Kansas Department of Agriculture Division of Water Resources PERMIT OF NEW APPLICATION WORKSHEET

<u>MEMORANDUM</u>

FROM: Doug Schemm RE: Application, File No. 50,404

APPROVAL OF APPLICATION and PERMIT TO PROCEED

Figure 1: Lithology logs

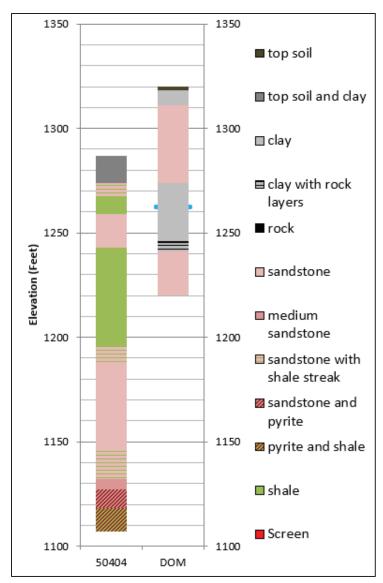
A Theis analysis was used to evaluate the potential impacts of a new application located in Section 21, Township 11 South, Range 3 West. The permit would authorize up to 201.5 acre-feet per year at 1400 gallons per minute. The drawdown was evaluated at the location of a domestic well located approximately 2,466 feet west. The assumed transmissivity (1,060 ft²/d) is based on lithological logs (Figure 1). Saturated thickness of 122 feet is based on a recent depth to water measurement at the domestic well. Specific storage was assumed to be 10⁻³, which results in a storativity of 0.12. The drawdown at the domestic well after 50-years of pumping cycles under these assumptions is 6.87 feet, or 5.63% of the projected future saturated thickness (Table 1).

Table 1: Drawdown evaluated at domestic well. $T = 1,060 \text{ ft}^2/\text{d}$; S = 0.12; ST = 122 ft

Pumping Well	Distance	Volume	Rate	Drawdown	Drawdown
	(FT)	(Acre-Feet)	(GPM)	(FT)	(%ST)
50,404	2,466	201.5	1,400	6.87	5.63 %

Based on David E.'s analysis, it does look like the projected drawdown is acceptable and reasonable. Even with Jim Corman's current saturated thickness of 41.6', the 50 year drawdown would still be less than 20%.
